To: T10 Technical Committee
From: Barry Olawsky, HP (barry.olawsky@hp.com) and
Rob Elliott, HP (elliott@hp.com)
Date: 13 October 2004
Subject: T10/04-337r0 SAS-1.1 TCTF Editorial Changes

Suggested Changes

5.3.11 Transmitter characteristics

Figure 51 — ~~Compliance interconnect~~ TCTF test load

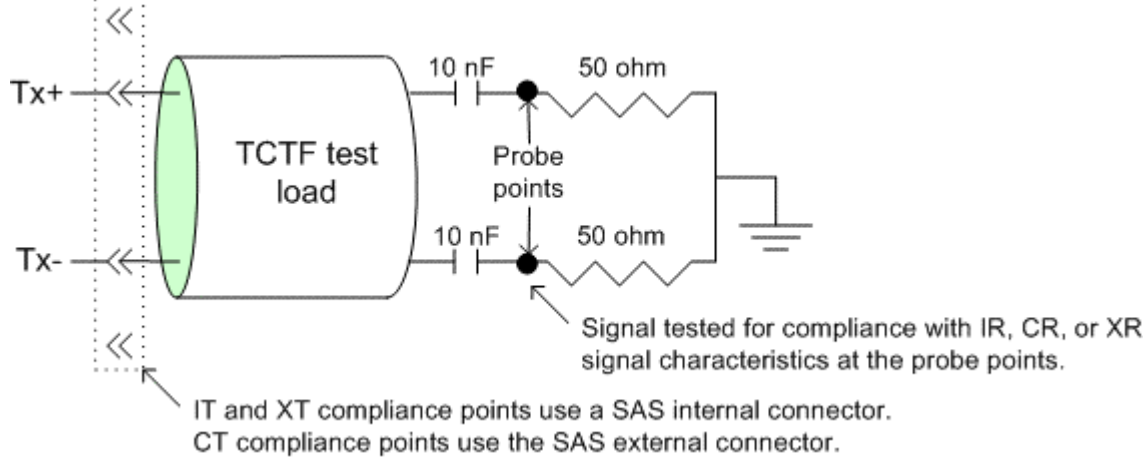
Text added to zero-length test load description mentioning that the transmitter compliance point signal characteristics must be met there. That rule is already stated in 5.3.4. Added text next to the probe points in the test load figures showing which signal characteristics are tested there.

Figure 51 shows the ~~compliance interconnect~~ TCTF test load.

Compliance with the TCTF test load requirement shall be determined by measuring the signal produced by the transmitter through a physical compliance interconnect TCTF test load attached to the transmitter compliance point (i.e., IT, CT, or XT) as shown in figure 51.

Figure 52 — Zero-length test load

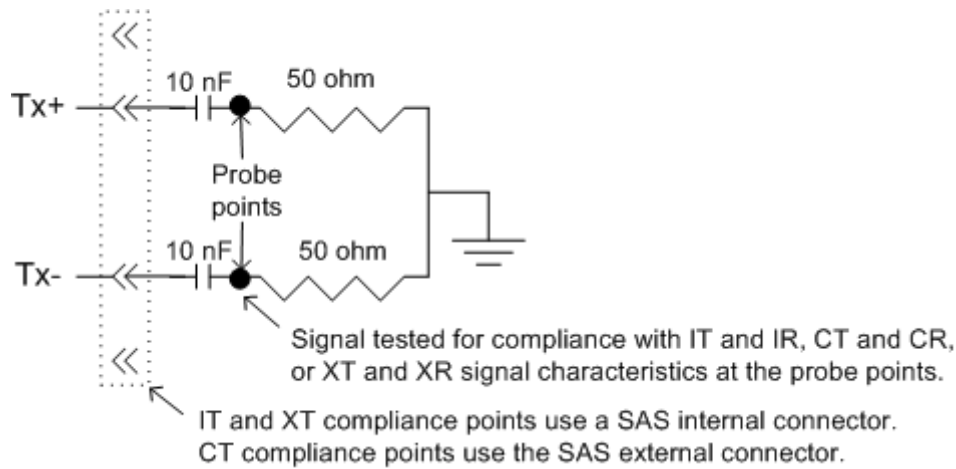
Figure 52 shows the zero-length test load.

Compliance with the zero-length test load requirement shall be determined by measurement made across measuring the signal produced by the transmitter through a load equivalent to the zero-length load attached to the transmitter compliance point (i.e., IT, CT, or XT) as shown in figure 52.

For the zero-length test load, the transmitter shall deliver a signal compliant with the signal characteristics specified for the transmitter compliance point (see table 29) being tested.

Figure 53 — ISI loss example TCTF S_{21} and ISI loss requirements at 3,0 Gbps

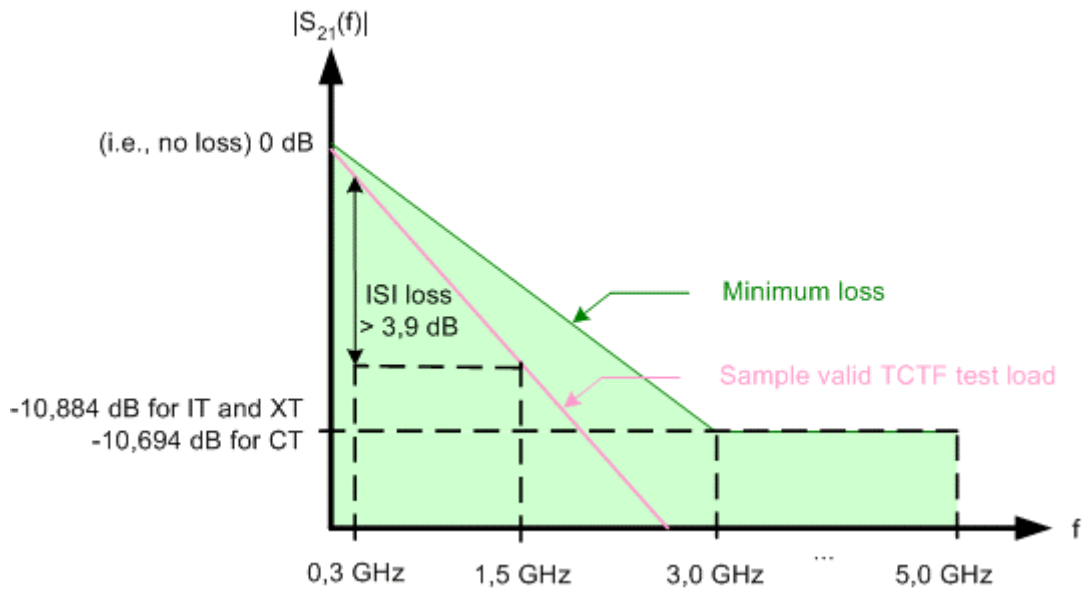
Figure 53 shows ~~an ISI loss example~~ the allowable $|S_{21}(f)|$ and minimum ISI loss of a TCTF test load and the $|S_{21}(f)|$ of a sample TCTF test load at 3,0 Gbps.

[Note to editor – Generate separate graphs for IT/XT and CT since the CT line is not straight.]

Figure 54 — ISI loss example TCTF S_{21} and ISI loss requirements at 1,5 Gbps

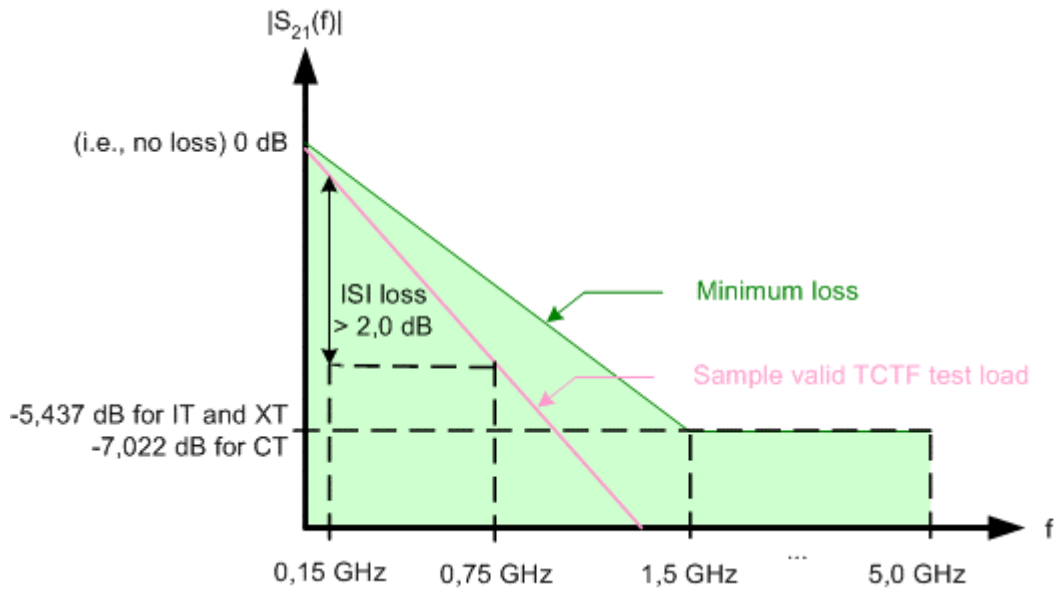
Figure 54 shows an ISI loss example the allowable $|S_{21}(f)|$ and minimum ISI loss of a TCTF test load and the $|S_{21}(f)|$ of a sample TCTF test load at 1,5 Gbps.
